Alfred Road PSP

Submission for the GAA draft Precinct Structure Plans open for public comment

Figure 1: Annotated plan with bicycle comments

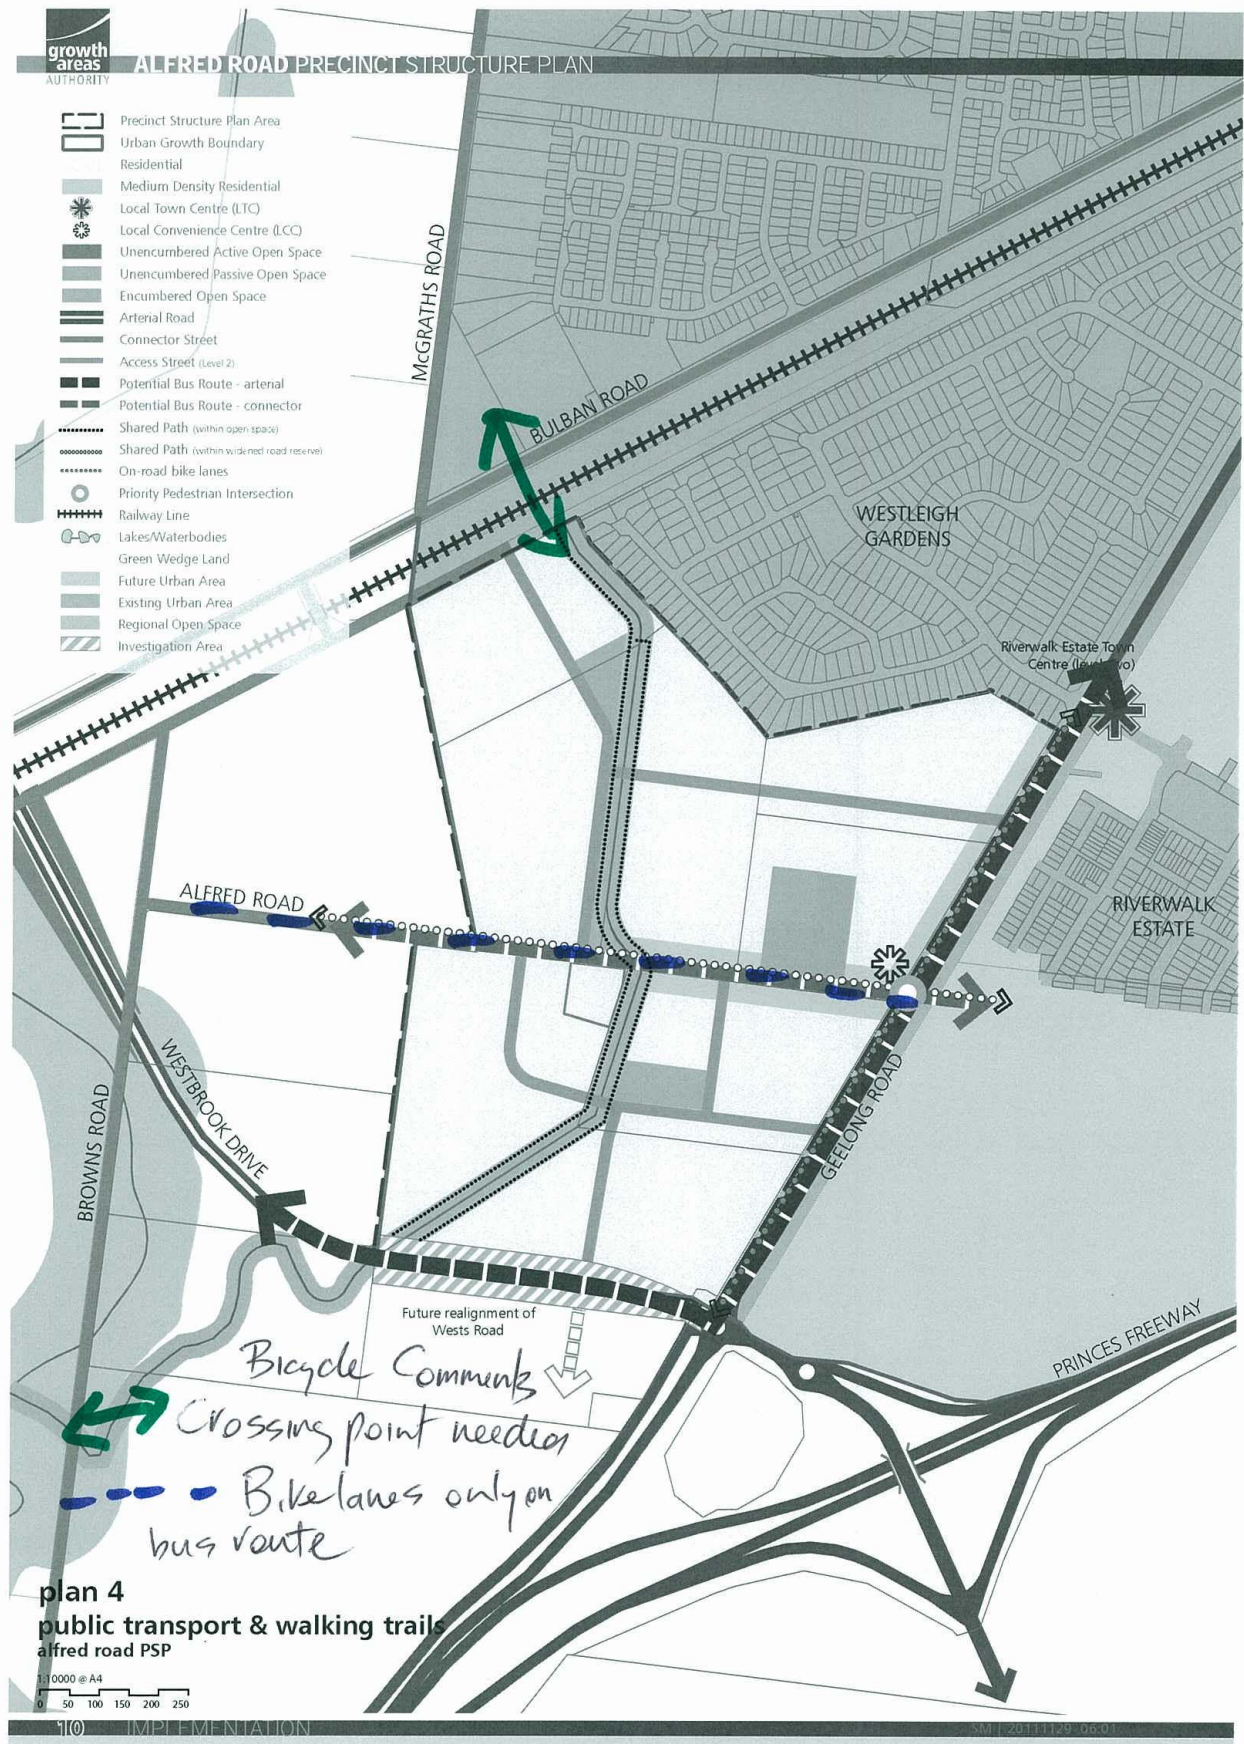
It is not clear what provision for bicycles is provided on Geelong Rd. Cross Section 3 shows bike lanes but Plan 4 indicates a shared path. There is no detail on bicycle provision on Westbrook Drive or its realignment which will provide connections into Riverwalk Estate and Blackforest Drive PSP.

Crossing of barriers – Crossings into Riverwalk Estate are important and seem to be shown at Alfred Rd. Crossings are also needed at Westbrook Drive and at the Riverwalk Estate LTC. To the NW the railway and Bulban Rd are potential barriers into Blackforest Rd PSP area. There are not

crossings shown on the plan. A crossing is needed where the shared path meets the railway in the NW (see annotated plan). Otherwise the path ends at a dead end with no outlet or connection north.

Figure 2: Annotated Subdivision Plan with bicycle comments

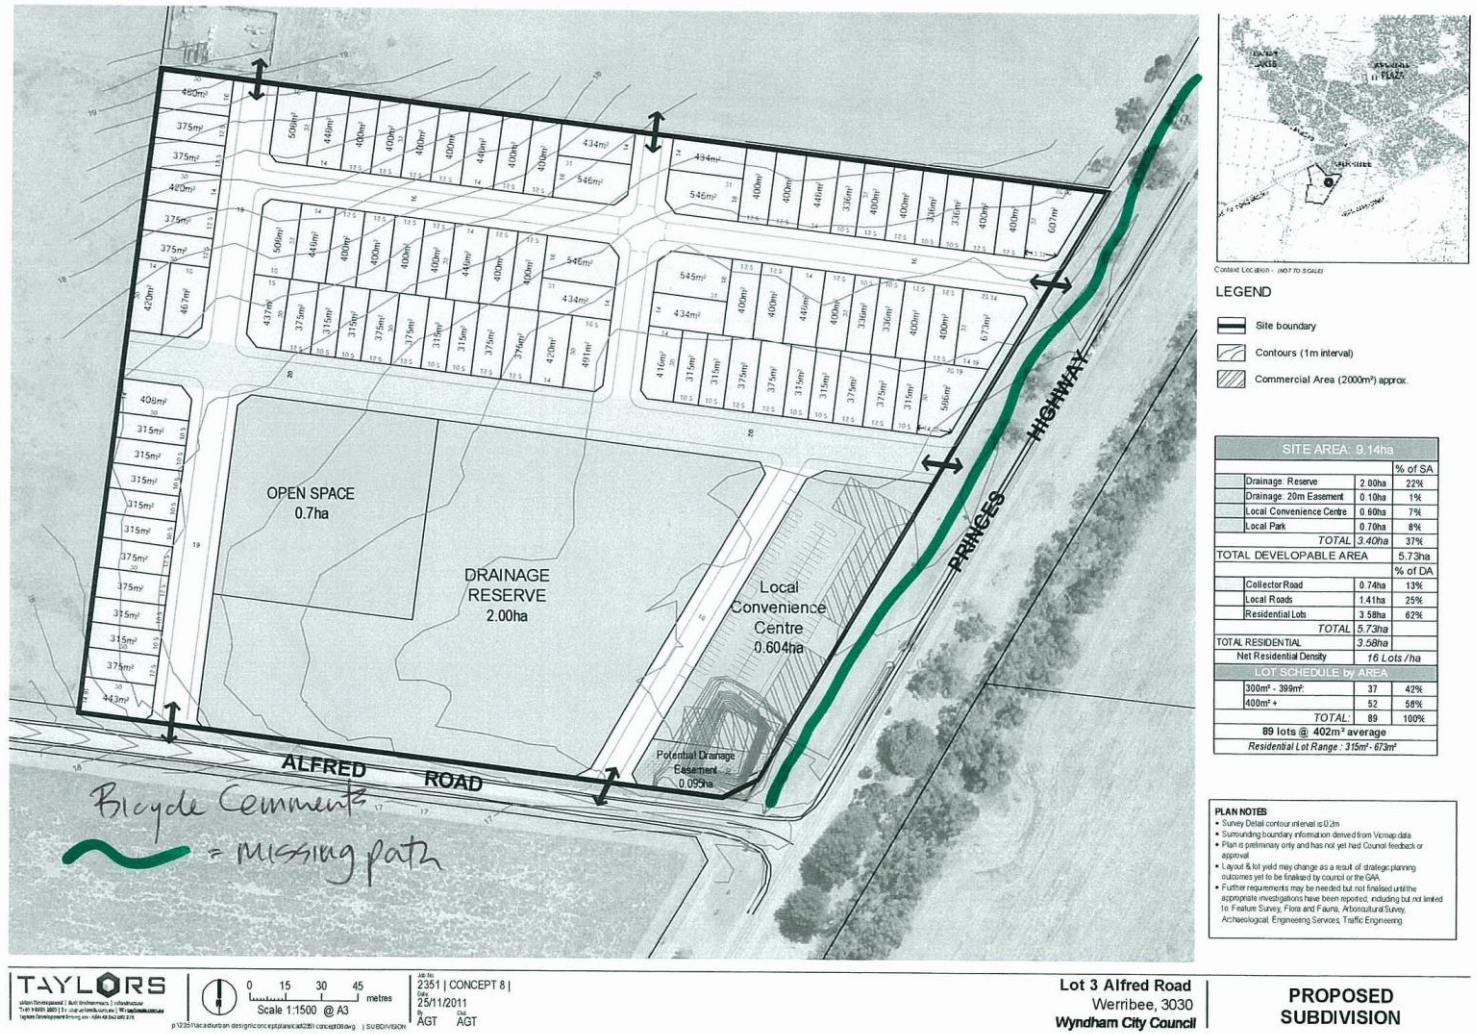
Does not show shared path alignment on Geelong Rd that would link to above two areas and is shown on Cross Section 4 of PSP. See Figure 2 attached which shows missing bike path.
